Service Bulletin

Bulletin No.: 21-NA-118

Subject: Vibration Type Noise Heard at Highway Speeds or with Engine Speed at 1,300-1,500 RPM

5776432

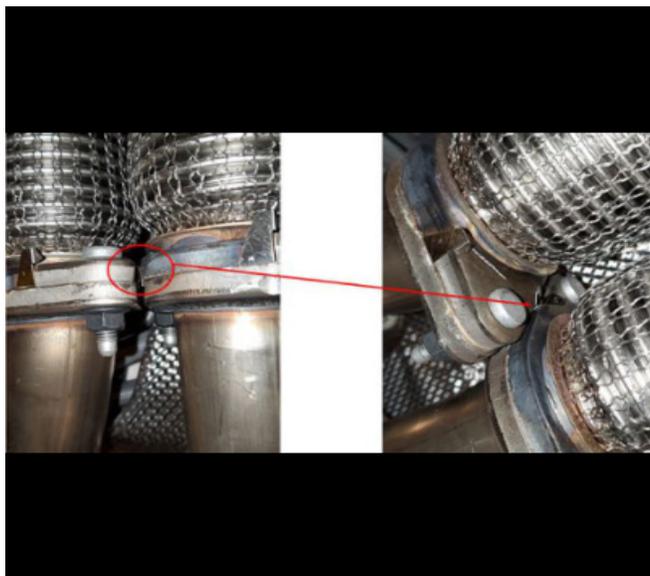
With a small punch or chisel and hammer bend/crimp the tabs on the exhaust gasket in further to prevent any spring-back and provide increased clearance between the two tabs to correct the noise or cutting the tabs off the gaskets is also acceptable.
